ADDENDUM 01

Project: Upstate – Palmetto Villas Crawl Space Repairs

JCS Project #: 18108

Date: 4/18/2019

SHEET TITLE: CRAWL SPACE PLANS AND DETAILS

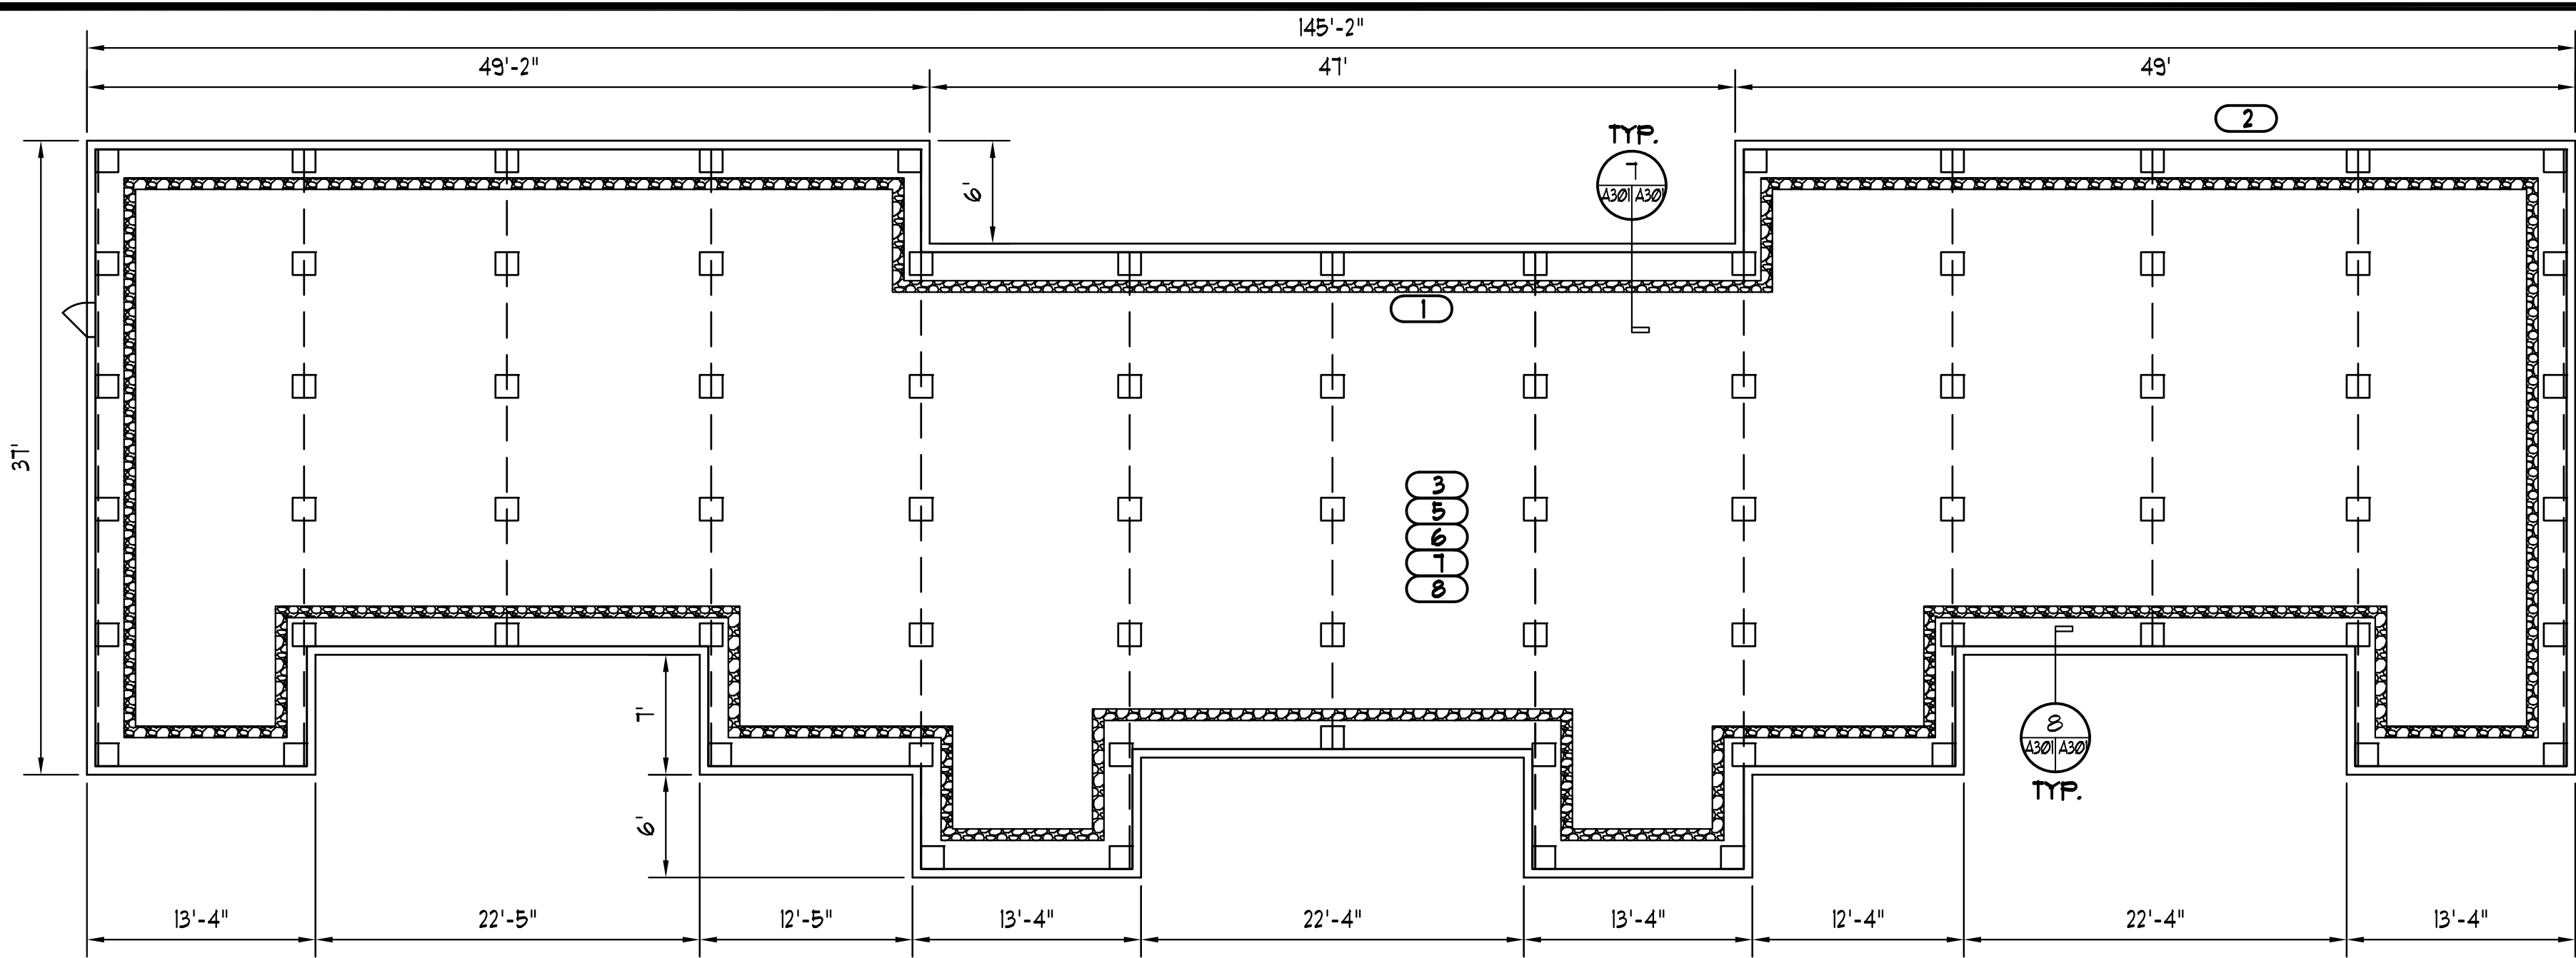
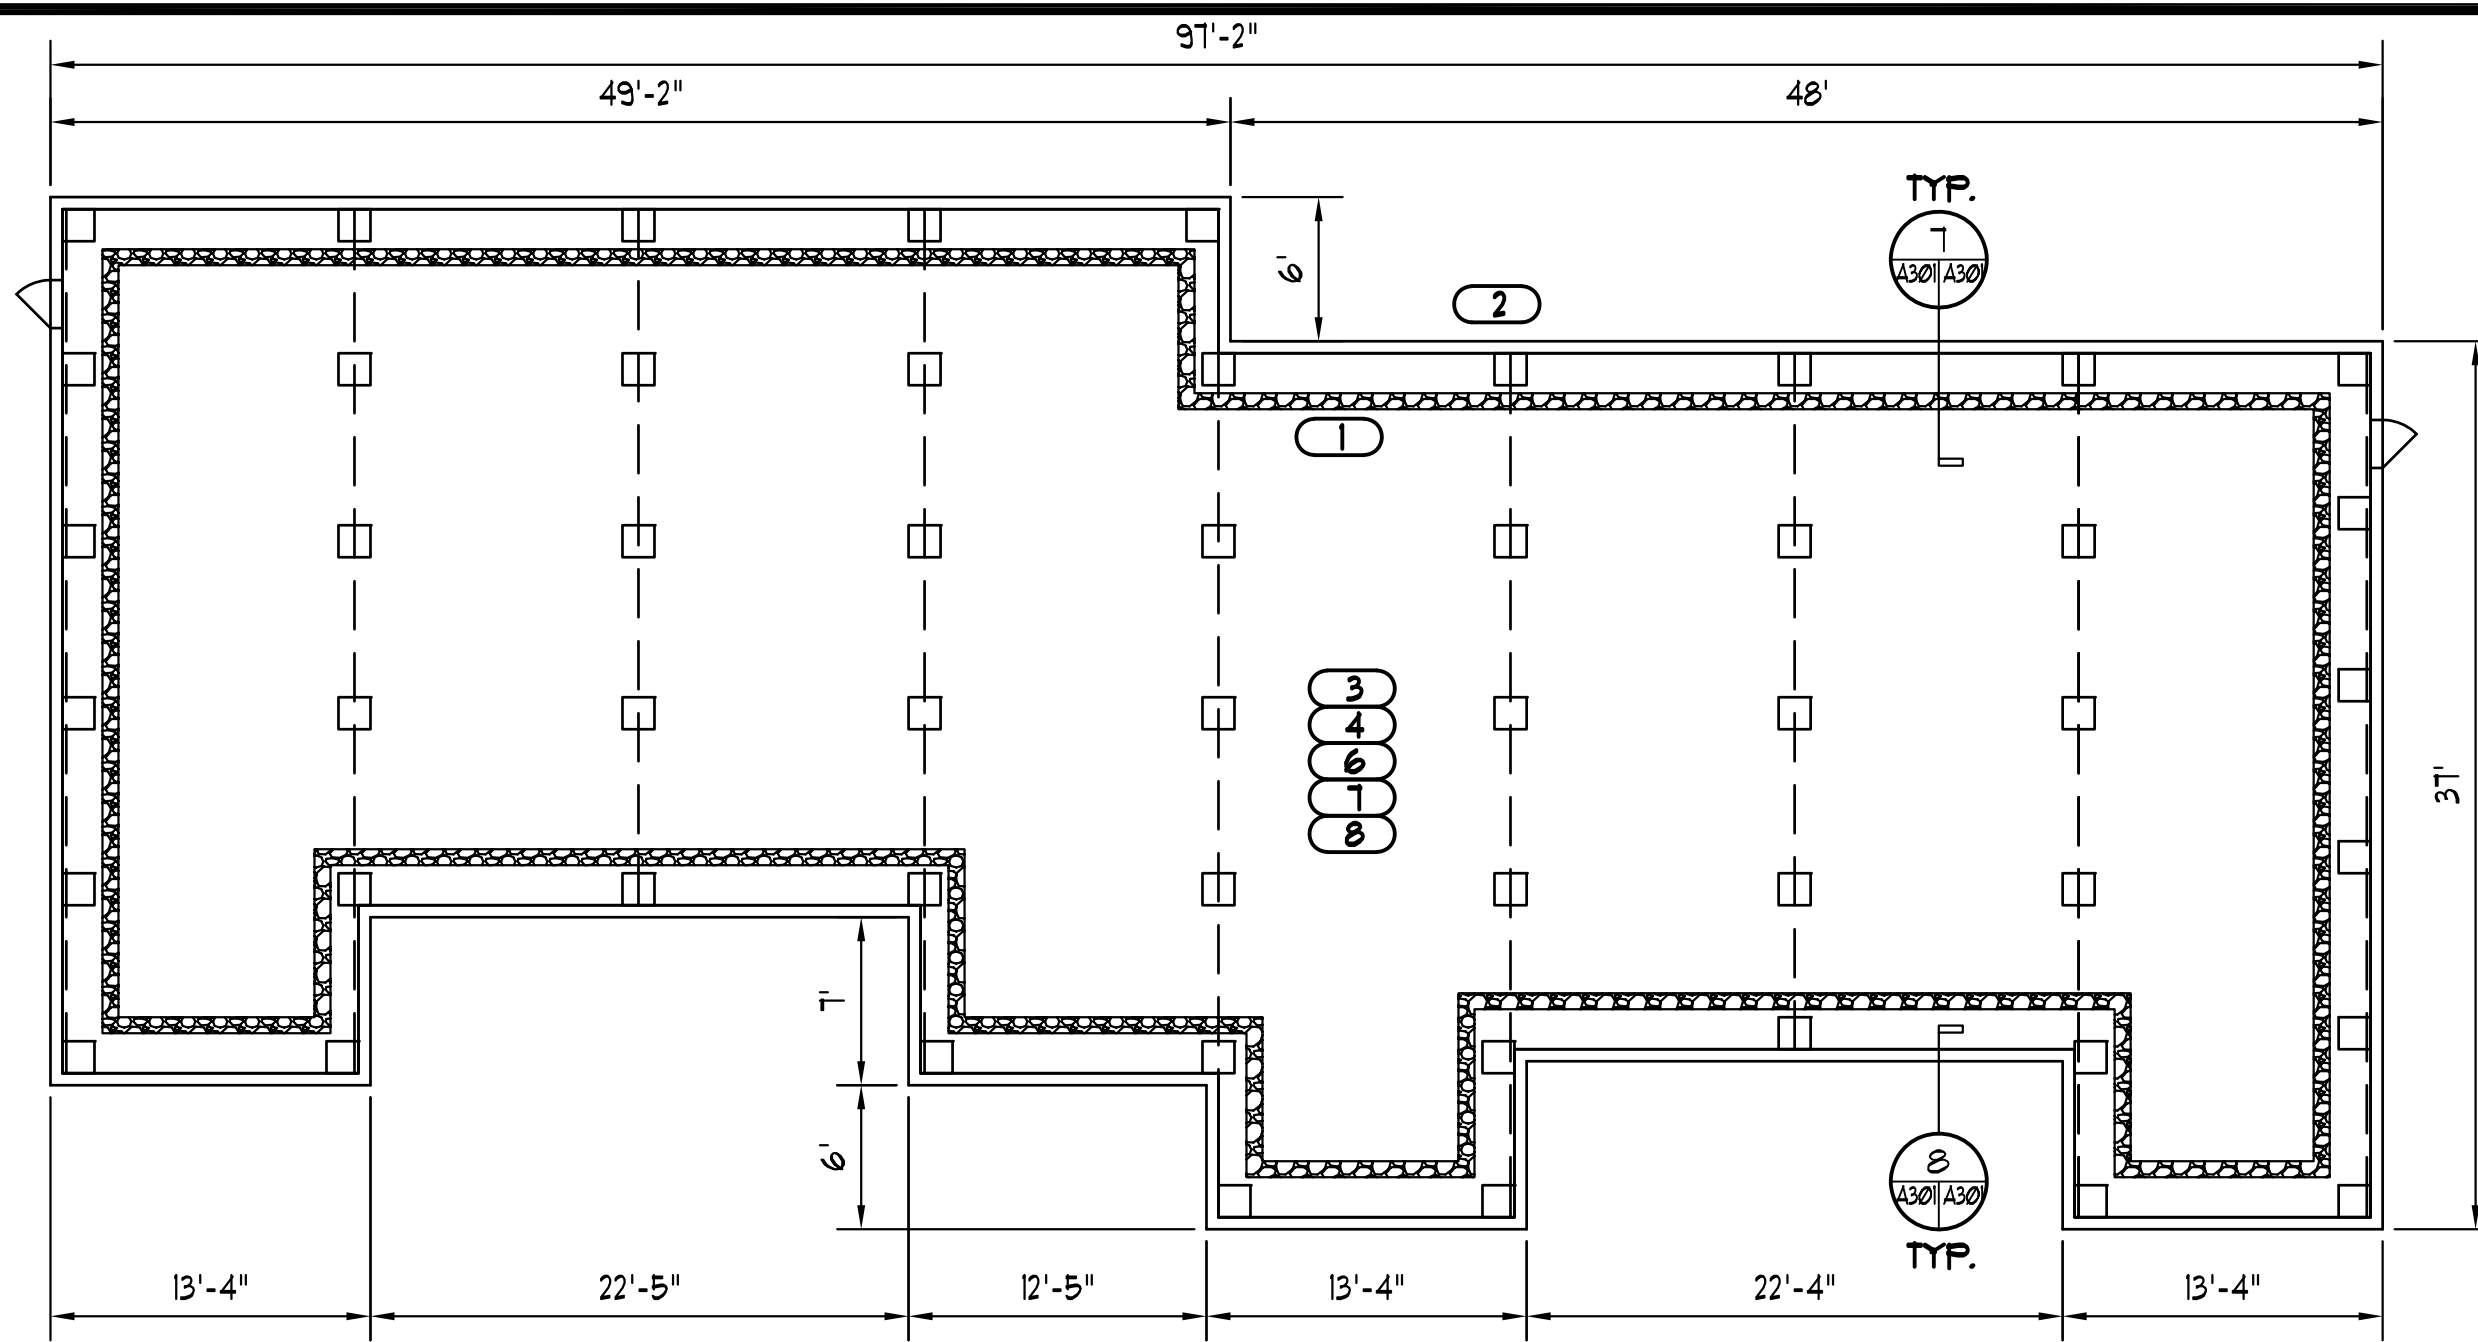
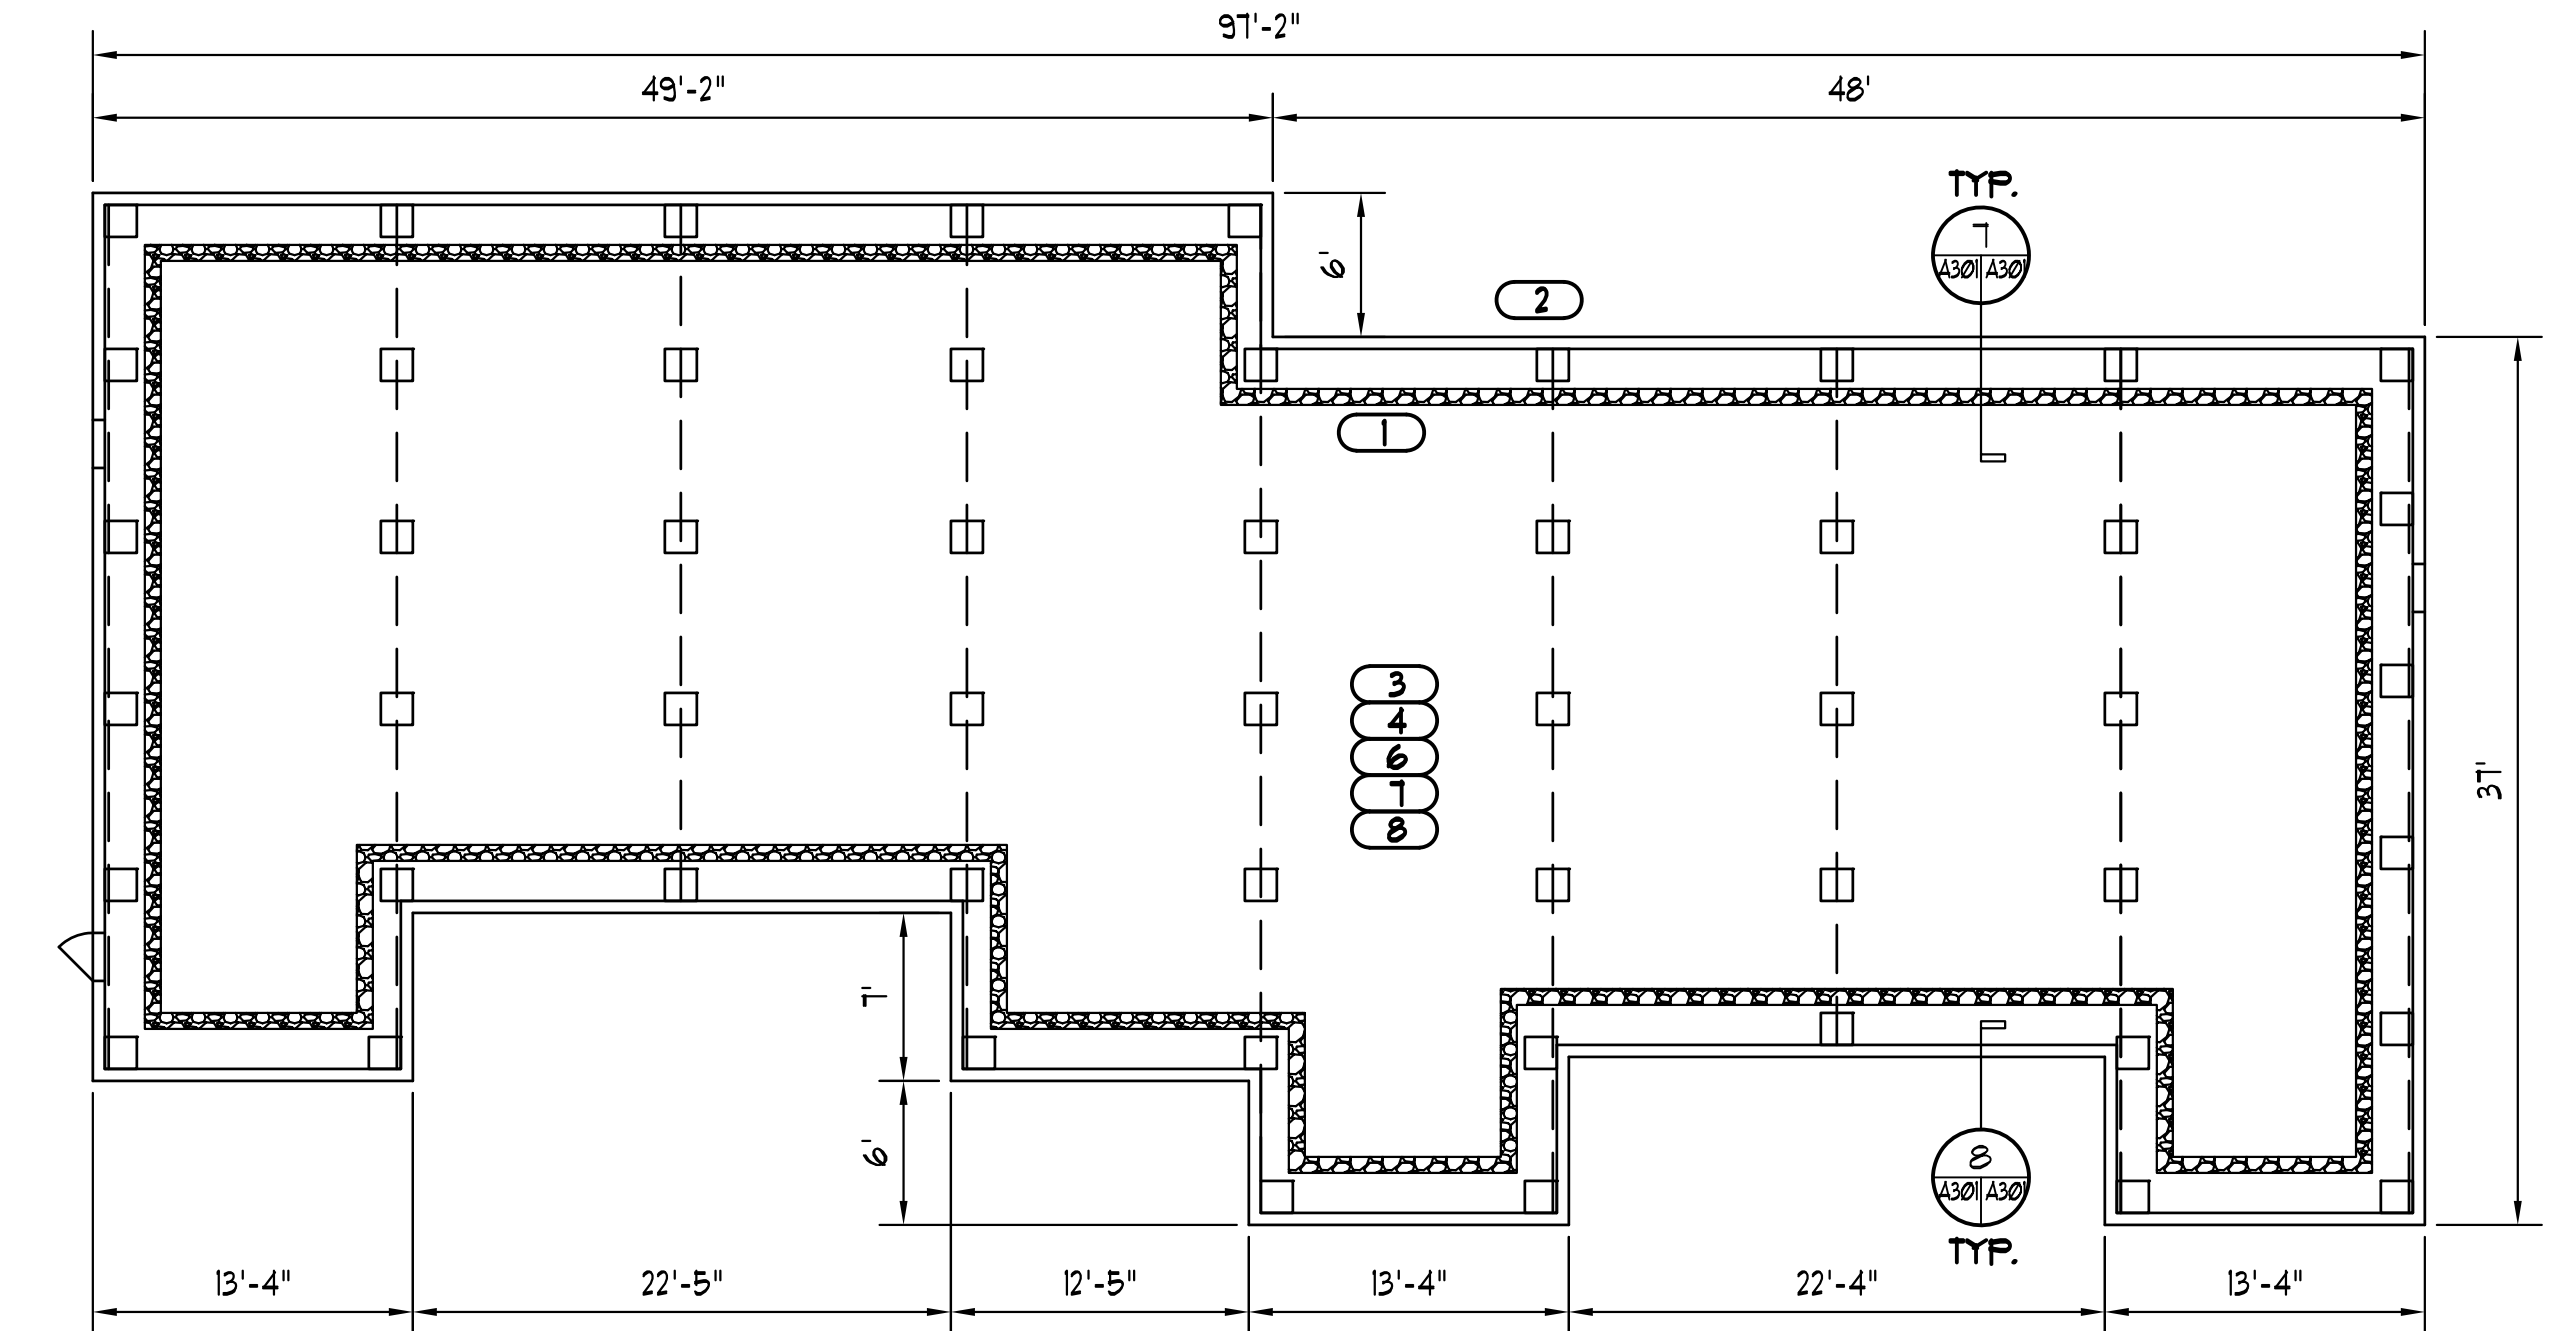
1. **Sheet A301, Crawl Space Plans and Details.** See attached revised sheet A301.
